# **BUSINESS PAPER**

**Extraordinary Council Meeting**

**7 REPORTS TO COUNCIL FOR DETERMINATION****7.1 VEOLIA ADVANCED ENERGY RECOVERY CENTRE - COUNCIL SUBMISSION TO THE ENVIRONMENTAL IMPACT STATEMENT****Authors:** Director Planning & Environment

3. Council makes a written submission to the NSW Department of Planning and Environment in relation to Development Application SSD-21184278 requesting that the following actions be undertaken by the applicant prior to an assessment being finalised:

Figure 17  
Photomontage PM1  
GREEN BEAN DESIGN  
landscape architects

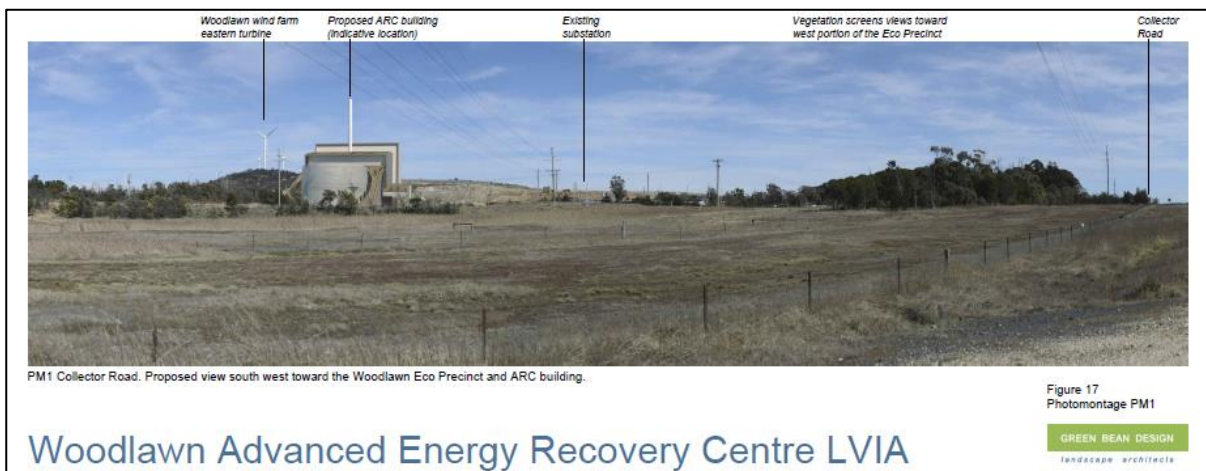
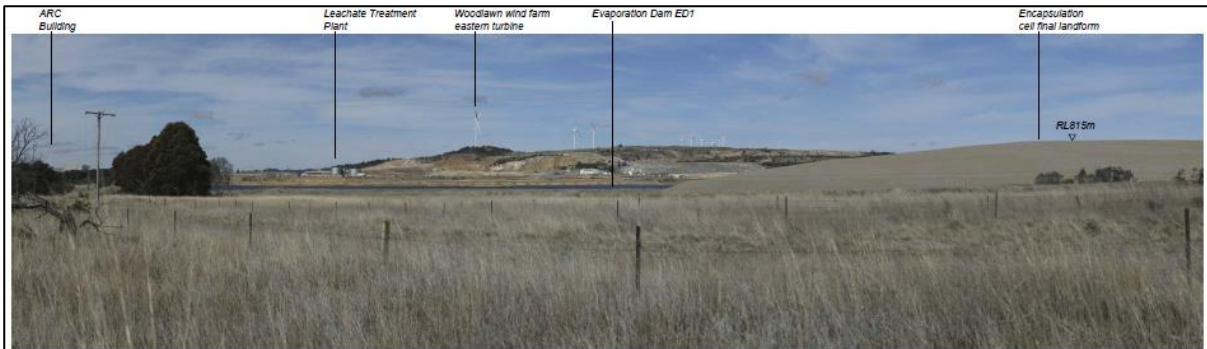
The ARC building is 54m high (see above). The emission stack is 85m high. By comparison the existing wind turbines at Woodlawn are 80m high to the hub (centre of the blades) and 124m at the highest point of the blades (noting that the base of the turbines is also at a higher elevation). The encapsulation cell is 30m high.

The most relevant photomontages from Appendix BB Landscape and Visual Impact Assessment are reproduced below. The most significant visual impact can be seen in the first image PM1 Collector Road. Screen planting in this area will reduce the visual impact. The same goes for the second image PM2 Collector Road, but the visual impact is less, given the increased distance from the development.

Planting will not be able to completely screen the development given the scale of the emissions stack and buildings, however it will reduce its visual impact. The area planted will have to be substantial to have a significant screening effect. When mature (after 50-100 years) certain Eucalypts found locally will reach a height of 25-30 metres, however this would only be achieved well beyond the anticipated life of the plant.

*ACTION: The plant species used for screening purposes should be selected from the Native Plant community found in the vicinity of the site.*

*A mixture of trees, shrubs and groundcovers should be used. This will provide an additional environmental benefit as well as screening the development.*

*ACTION: A long term planting maintenance schedule should be provided and adhered to. The maintenance plan should contain a schedule of works that includes an annual timeline for weed management, plant replacement where needed, monitoring for pests and diseases, and watering etc.*

Figure 3 - Chart 1 page 10 of Appendix E

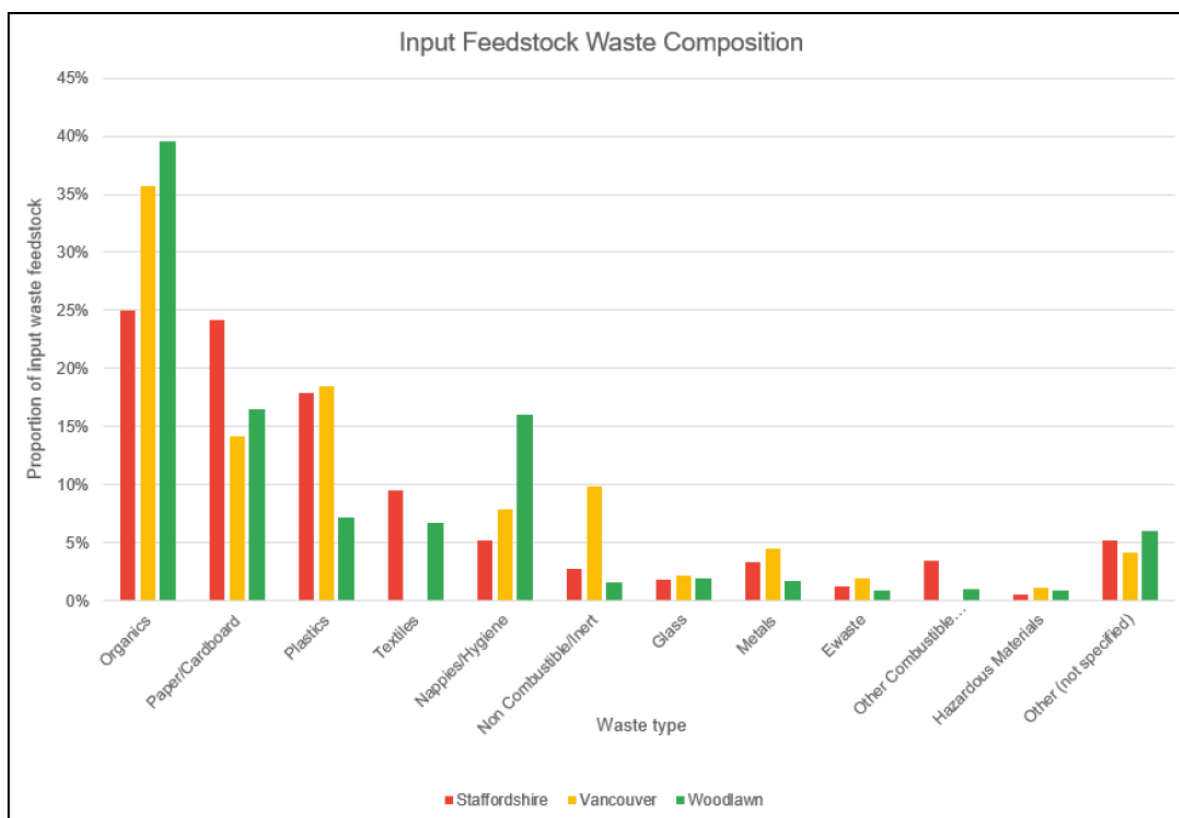
- *Organics comprise a higher proportion of the feedstock for Woodlawn than the reference plants, by up to 15% -*

This doesn't appear to be correct because it is just looking at the number on the graph. The reality is Woodlawn will process about 60% more organics than Staffordshire (UK). 15% sounds better than 60%

*ACTION: Appendix E makes assumptions on the likely waste outputs based on the comparison with other EfW plants, however, data used to justify the argument that the "input waste stream will be generally the same" in fact demonstrates that the reference data is dissimilar. Consequently, a different waste input stream would result in a different waste output. Therefore, Appendix E cannot be used to support the likely waste outputs because it is modelling different data. A reevaluation of the waste input model is required.*
